NOTICE AND AGENDA BRIGHAM CITY PLANNING COMMISSION

**BRIGHAM CITY, UTAH
PLANNING COMMISSION
STAFF EVALUATION**

APPLICANT: Colin Jube and Andrew Laing
PROPERTY OWNER: BC Fuel Center Holding LLC
PROPERTY ADDRESS: 1560 North 2400 West
PARCEL NO.: 03-074-0055 (Portio of **03-074-0017)

Permitted Use Permit – Fuel center, convenient store, and quick-service restaurant

OVERALL SITE PLAN

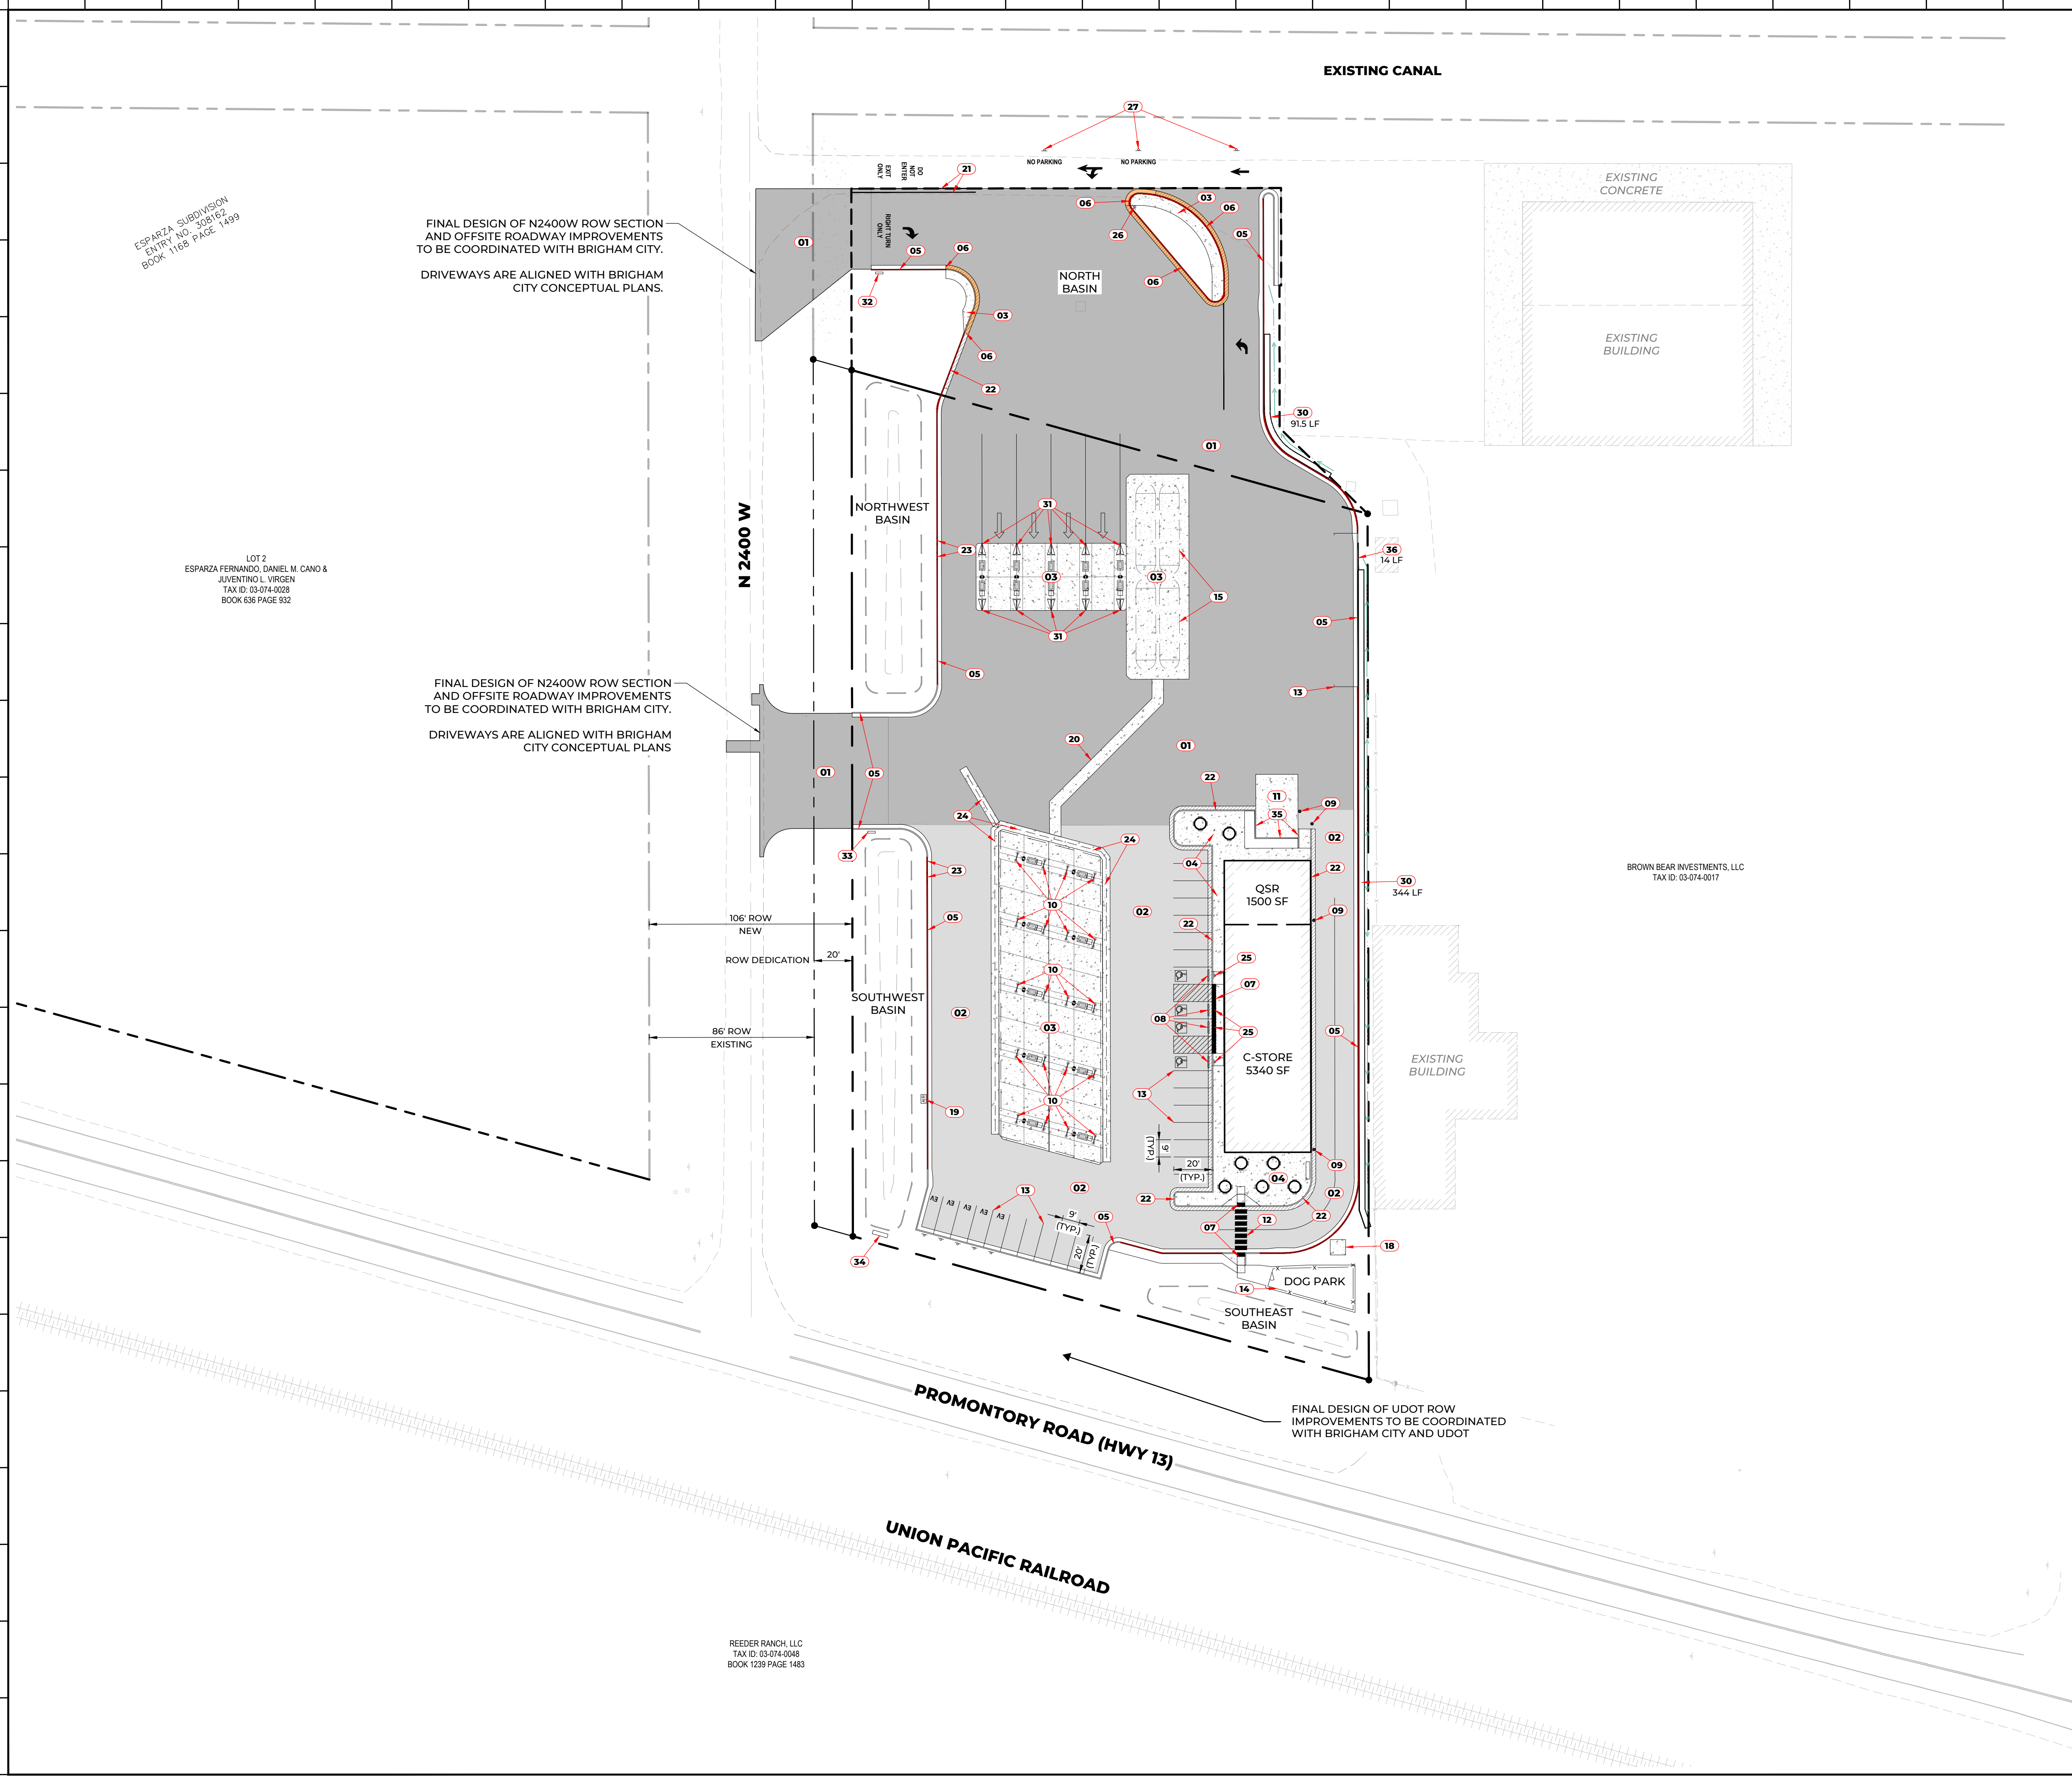
1. Overall Site Plan
 - A. Zoning / Land Use. Site Data Legend.
 - i. Remove “Existing Box Elder County Zoning ...”
 - ii. Remove “Proposed” in front of Brigham City Zoning.
 - iii. Land Use. Update to state actual use.
 - iv. Building Setbacks can be removed where it is based on design review (easement location, clear view, etc.) and not set distances.
 - v. Provide Proposed Building Height
 - vi. Provide Proposed Building Coverage
 - B. Notes
 - i. Where is Trailer Truck Parking Space?
 - ii. Provide the following in the Notes section:
 - a. Impervious Surface Area
 - b. Pervious Surface Area
 - c. Parking Required
 - d. Parking Provided
 - e. Accessible Parking Required
 - f. Accessible Parking Provided
 - g. Number of Fuel Dispensers
2. Parking. Address parking requirements per Brigham City Code. It appears the site is shy of meeting the number of required parking spaces.

- A. C-Store (Retail) – 1 parking stall per 250 sq. ft. of gross floor area.
 - B. QSR (Restaurant and Fast Food) – 1 parking stall per 100 sq. ft. of gross floor area or 1 space for each 4 seats whichever is greater with a minimum of 5 spaces for employee parking.

- C. Would like to better understand the nature of the QSR portion. Is it a stand-alone restaurant or an element of the C-Store?
- 3. Drive Thru. Drive up windows shall provide sufficient stacking room and sufficient area for 4 spaces from place of order and 4 spaces from pick up window.

- A. Show Order Menu Board
 - B. Show Pick Up Window
 - C. Show Vehicle Stacking
- 4. EV Charging Stalls. The EV charging stalls do not count toward the minimum required site parking.

- A. Show equipment and transformer location.
 - B. Provide plans for equipment screening.
- 5. 2400 West Street.
 - A. Show 2400 West Street Improvements on the civil plans.

- B. Provide a deed to Brigham City for the 20 ft right-of-way dedication.
- 6. Highway 13 (SR-13). Show any required UDOT improvements on the plans.
- 7. Signage. Provide a note on the site plan that “All signage requires a separate Brigham City Sign Permit.”

- 10. Cross Access Agreement. Provide a note on the site plan referencing the cross access agreement and include a line space for the recording entry number.

- 11. Dumpster enclosure. Provide an enclosure detail and a note on plans that enclosure to have similar material and/or color as main building. The note can be on Sheet C.1.0. Add to Note #11.

- 12. Show semi-truck circulation and include site signage to manage the traffic between automobiles and semi-trucks.
- 13. Landscape
 - A. Update Landscape Plan to 2400 West Street improvements. Show proposed landscape in the park strip between curb and sidewalk.

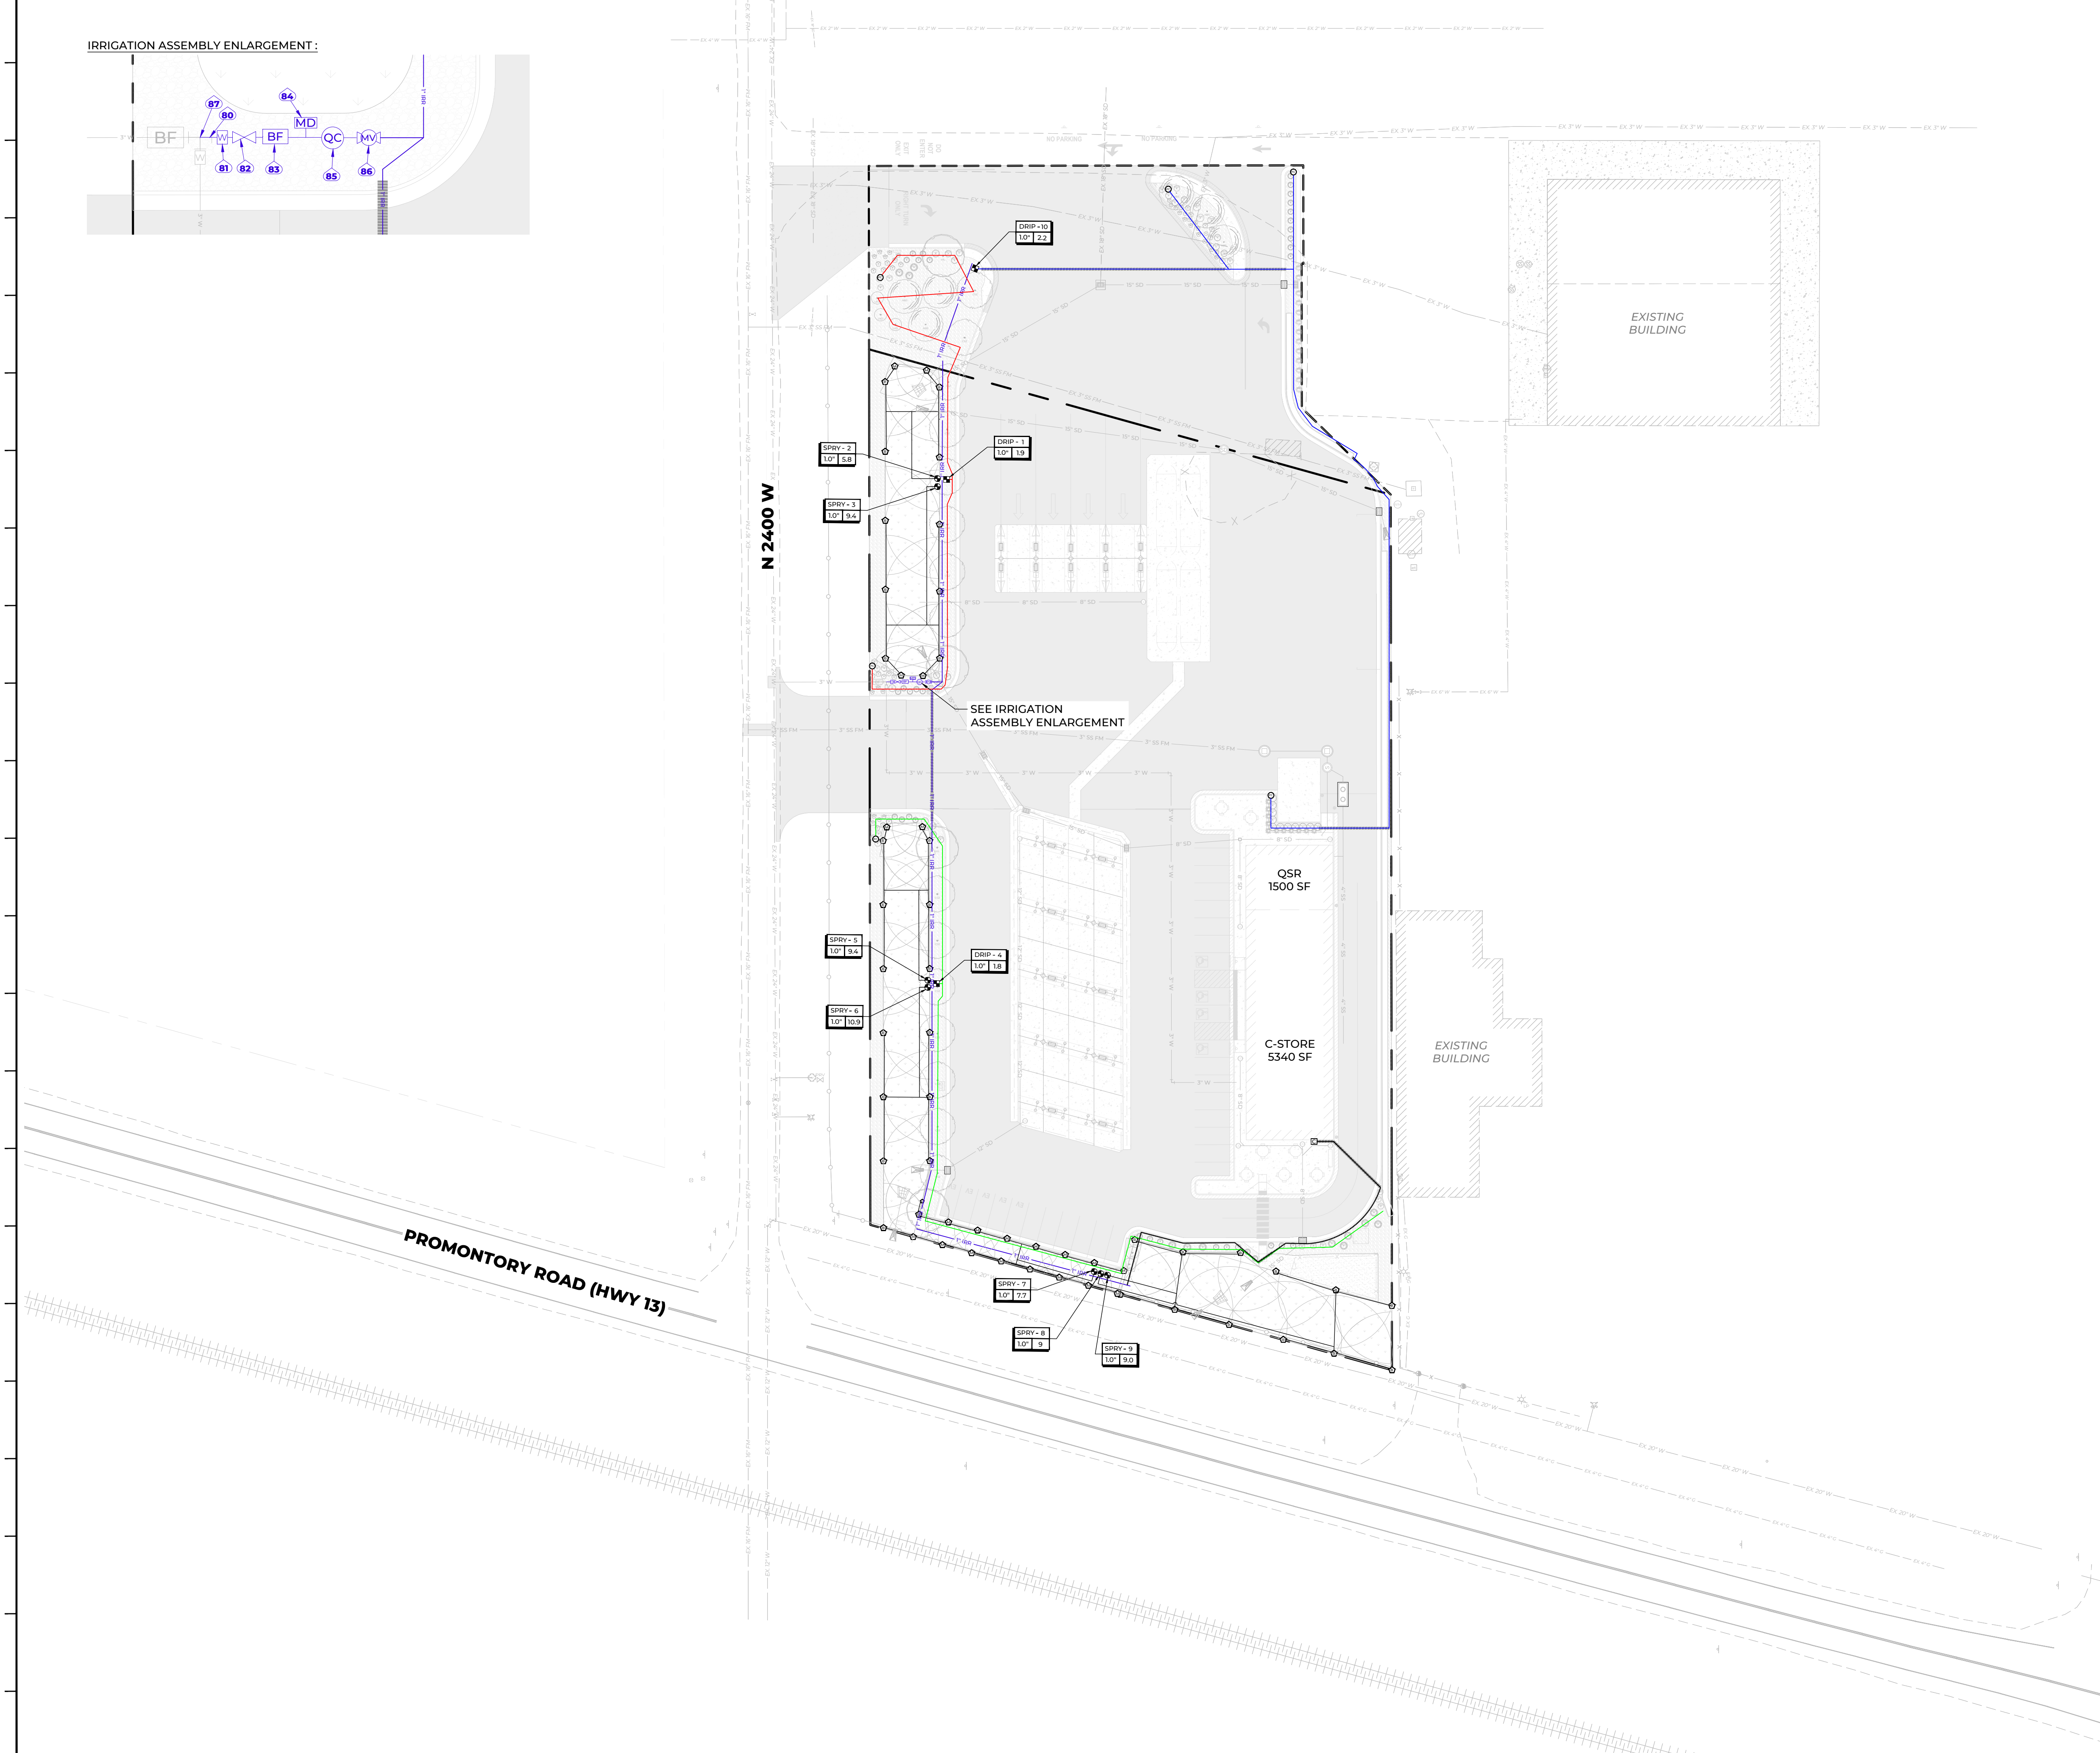
- B. Please include symbols for the trees and shrubs with the Plant Schedule.
 - C. It seems odd to have crushed stone for the Dog Run area. Wouldn't lawn be more suitable in this area?
